Access Compliance Report

Public Rights-of-Way

(Curb Ramps)

Intersection ID: 12160	Main Street: E_9TH_ST	Cross Street: N_BREVARD_ST	Location: N
ADA ID: D0B63E3F9EB6	Ramp Type: BlendTrans1	Initial Pass/Fail: Fail	Overall Compliance: No
			Severity Score: 21.25

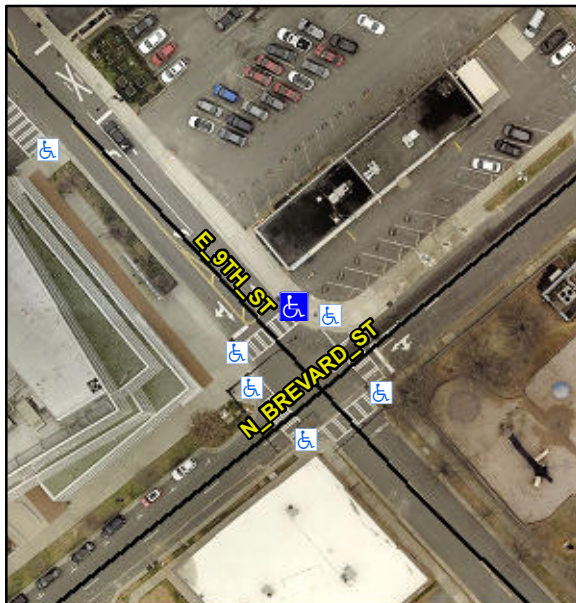
R304.5.1, R304.5.3

Compliance	Description	Data	Compliance	Description	Data
N/A	Ramp Length (in)	72.0	Yes	BlendTrans Slope (%)	3.3
No	Ramp Width (in)	47.0	No	BlendTrans XSlope (%)	5.6
N/A	Flare Type LT	N/A	N/A	Flare Type RT	N/A
N/A	Flare Slope LT (%)	N/A	N/A	Flare Slope RT (%)	N/A
N/A	Flare Traversable LT?	N/A	N/A	Flare Traversable RT?	N/A
N/A	Landing Length (in)	N/A	N/A	DWS Provided?	N/A
N/A	Landing Width (in)	N/A	N/A	DWS Contrast?	N/A
N/A	Landing Slope (%)	N/A	N/A	DWS Length (in)	N/A
N/A	Landing X Slope (%)	N/A	N/A	DWS Full Width?	N/A
N/A	Landing Curb? (Y/N)	N/A	N/A	DWS Offset (in)	N/A
N/A	Shared Landing?	N/A			
N/A	Gutter Ponding?	N/A	N/A	Gutter Slope (%)	N/A
N/A	Gutter Lip Ht (in)	N/A	N/A	Gutter X Slope (%)	N/A
N/A	Painted X Walk1?	Yes	N/A	Painted X Walk2?	N/A
	X Walk 1 Direction	To SW		X Walk 2 Direction	N/A
	X Walk 1 Width (in)	104.0		X Walk 2 Width (in)	N/A
	X Walk 1 Slope (%)	1.4		X Walk 2 Slope (%)	N/A
	X Walk 1 X Slope (%)	0.5		X Walk 2 X Slope (%)	N/A

Remove & Replace Curb Ramp With Two New Directional Ramps or Equivalent.
